<b>Document Name</b>	<b>Date</b>	<b>Rev.</b>	<b>Page</b>	<b>E-DOC</b>
	620L/622L ROPE GRIPPER® 4-WIRE CONNECTION UPDATE	05/30/23	A	1 of 1	177

Figure 1: Original Schematic Label

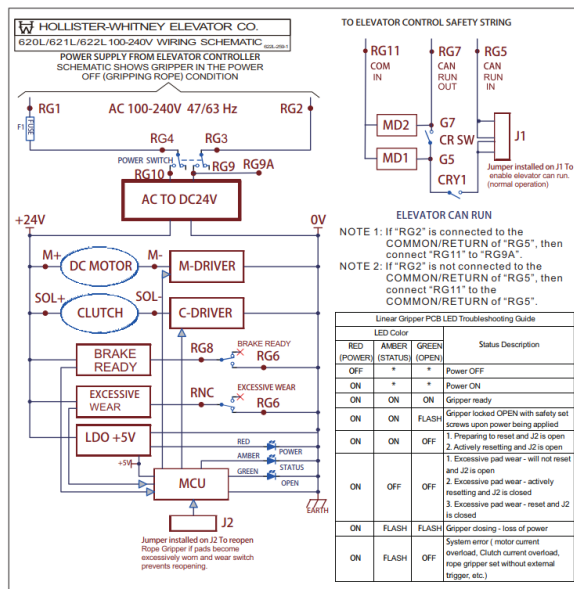
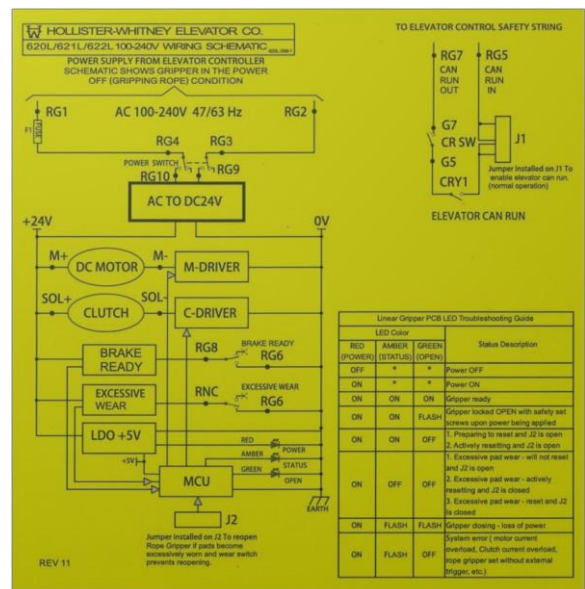
The linear series of Hollister-Whitney Rope Grippers has been updated from its original launch configuration of a 5-wire connection from the controller to support a 4-wire connection from the controller. A software update has been implemented which no longer requires RG11 to be connected to the common of the elevator control safety string. Also as a result of the software update the functionality of MD1 and MD2 is no longer required. Please note that the new schematic on the back of the cover no longer shows RG11, MD1, and MD2. The original schematic label can be seen below in Figure 1 and the updated schematic label can be seen below in Figure 2.

Updated software and the updated schematic label will be supplied for all replacement board orders for the original 5-wire configuration. You will not need to connect RG11 when replacing an original board version but if RG11 is connected to the common of the elevator control safety string the functionality will remain the same. A new schematic label will also be supplied to replace the 5-wire connection schematic label on the back of the cover on replacement board orders.
